**RESOLUTION HOLDING HEARING ON REQUEST FROM PINNACLE ON FLEUR, LLC TO AMEND
PUD CONCEPTUAL PLAN FOR PROPERTY LOCATED AT 2710 AND 2500 FLEUR DRIVE**

(ZON2020-00028)

FIRST AMENDMENT TO THE CONCEPTUAL PLAN THE VILLAGE AT GRAY'S LAKE

UNIT A-SIDE

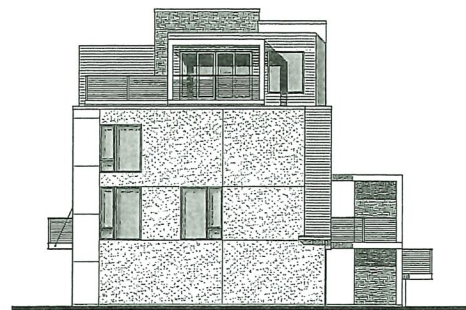
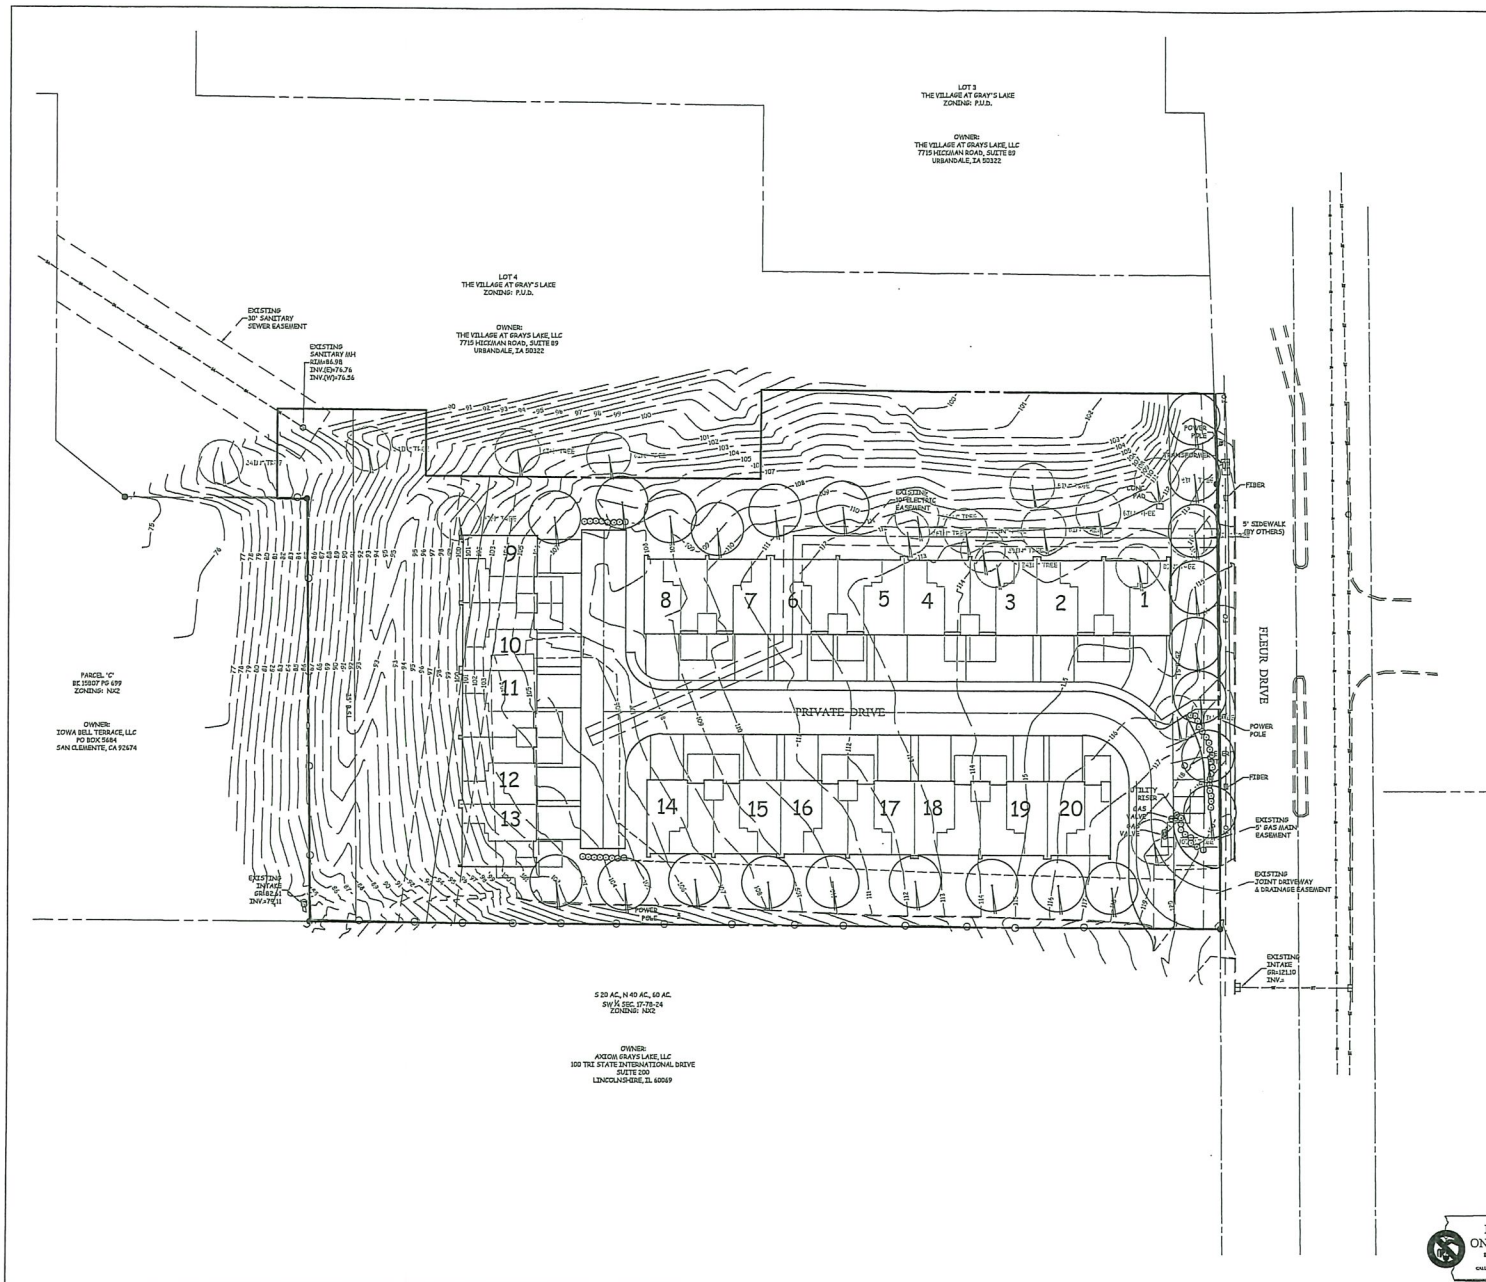
4. Revise typical Row House Type elevations to:
- a. label required materials.
 - b. show stone material wrapped around 360 degrees of the buildings on the main story level, exclusive of windows and door openings.

- c. show end unit elevations for facades of the units closest for Fleur Drive with a separate pedestrian entrance either from the garage or unit that would have a walkway to the private drive. The entrance shall be defined with a design appropriate awning or cover.

- d. show a minimum of 12% transparency on the façade of the lower/garage floor ends of the buildings oriented toward Fleur Drive. More transparency may be required to receive tax abatement.

Staff believes that the stone material should be wrapped around 360 degrees of the building, exclusive of windows and door openings. The end facades of the units closest for Fleur Drive should have a separate prominent pedestrian entrance either from the garage or unit that would have a walkway to the private drive. This entrance should have an awning reflective of the building design. Additionally, staff believes that there should be a minimum of 12% transparency on the façade of the lower/garage floor ends of the buildings oriented toward Fleur Drive. This is consistent with other Row House Type end facades in other PUD developments when they have faced a public street. *Note: Additional transparency may be required if seeking tax abatement.*
